**RESPONSE TO REQUEST FOR ADDITIONAL INFORMATION**

**US-APWR Design Certification**

**RAI NO.:** NO. 876-6210 REVISION 3  
**SRP SECTION:** 08.03.01 - AC POWER SYSTEMS (ONSITE)  
**APPLICATION SECTION:** TIER 2, SECTION 08.03.-1  
**DATE OF RAI ISSUE:** 12/15/2011

**QUESTION NO. : 08.03.01-43**

**Fig.1 Appearance of fuel nozzle and its installation position**

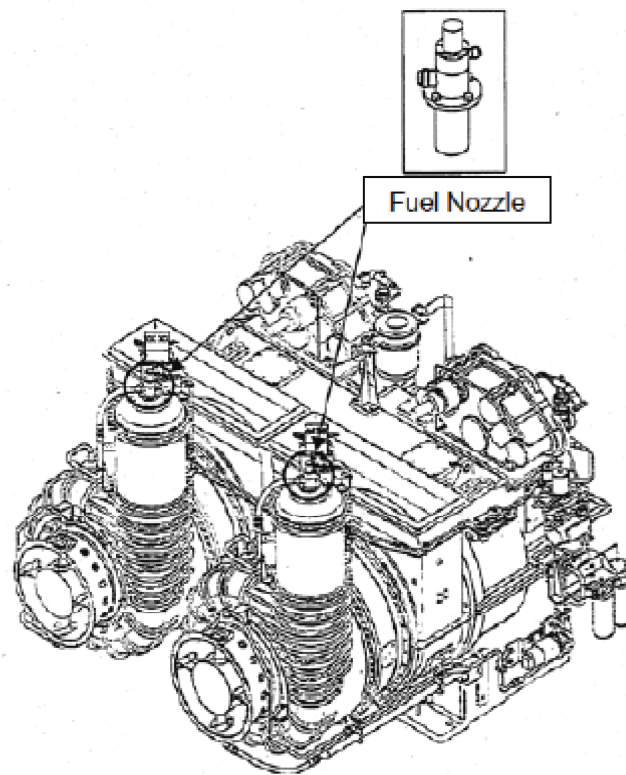
- a. Provide information to support that the scheduled maintenance activity conducted was part of the test procedures because this information was not provided in the submitted technical reports, MUAP-07024-P (R2), "Qualification and Test Plan of Class 1E Gas Turbine Generator System", MUAP-10023-P (R3), "Initial Type Test Result of Class 1E GTG System", and Technical Specifications.

- b. Provide details related to the maintenance procedures defined prior to conducting the start and load acceptance tests, and document this maintenance activity in the US-APWR DCD in all appropriate sections where GTG qualification is discussed, as well as in the Qualification Plan Technical Report, MUAP-07024-P (R2).
- c. Add an ITAAC in the DCD, Tier 1, Table 2.6.4-1, "EPS Systems Inspections, Tests, Analyses, and Acceptance Criteria," in order to verify the qualification of the GTGs.
- d. Provide the detailed written plan that defines analysis and tests to be performed, parameters to be monitored during tests, test instrumentation, and acceptance criteria for equipment that was followed during the qualification testing of the GTGs.

Fuel nozzle cleaning was not discussed in the test plan report, MUAP-07024-P(R2) "Qualification and Test Plan of Class 1E Gas Turbine Generator System" however, the engine manufacturer's procedures, which included fuel nozzle cleaning, existed prior to the test. An engine manufacturer's representative was present to support the test and perform the manufacturer's recommended maintenance and inspections. The fuel nozzle cleaning is discussed in MUAP-10023-P(R3) "Initial Type Test Result of Class 1E Gas Turbine Generator Systems," Subsection 6.3.2 Item e. This maintenance activity is one of several recommended by the engine manufacturer. It was the only recommended maintenance item triggered during the series of tests. The intent is to prevent the buildup of gums and other insoluble materials, such as carbon within the fuel nozzle and the fuel nozzle tip; this buildup is commonly referred to as "fuel nozzle coking." The general effect of severe coking is a reduction in ignition and operating performance over time.

Cleaning of the fuel nozzles installed on the gas turbine engine (Fig. 1) will be conducted in accordance with the engine manufacturer's standard maintenance procedures which were reviewed and approved by MHI prior to cleaning. These procedures were not included in the test plan report, MUAP-07024-P(R2); however, the report will be revised to clarify the division of responsibility associated with the qualification testing. The responsibility for performing any manufacturer's recommended maintenance is assigned to the engine manufacturer's technical representative. Additionally, any required maintenance is to be performed in accordance with MHI approved procedures. The approved test procedure along with documentation that the maintenance was performed shall be included in a revision to the test results report, MUAP-10023-P(R4). A summary of the fuel nozzle cleaning procedure is provided below. This summary will also be included in the revision to the test plan report, MUAP-07024-P(R3).

Cleaning work shall be carried out after every 50 engine starts.

Work including preparation and clean up are estimated to take approximately two hours.

1. Disconnect the two fuel lines and a cooling air flexible tube from the fuel nozzle. Remove the four bolts and the fuel nozzle from the engine.
2. Perform rough cleaning of any apparently dirty sections with waste cloth.
3. Soak fuel nozzle in a detergent solution for 0.5 ~1 hour.
4. Brush the end of the fuel nozzle with a soft brush.

5. Rinse the fuel nozzle with clean water, and wipe with soft waste cloth.
6. Reinstall the fuel nozzle on the engines with new gaskets and washers.
7. Reconnect the fuel lines and the air cooling tubes to the nozzles.
8. Start the engine and operate it for 2-3 minutes to check for fuel oil or lube oil leakage or abnormal noise.
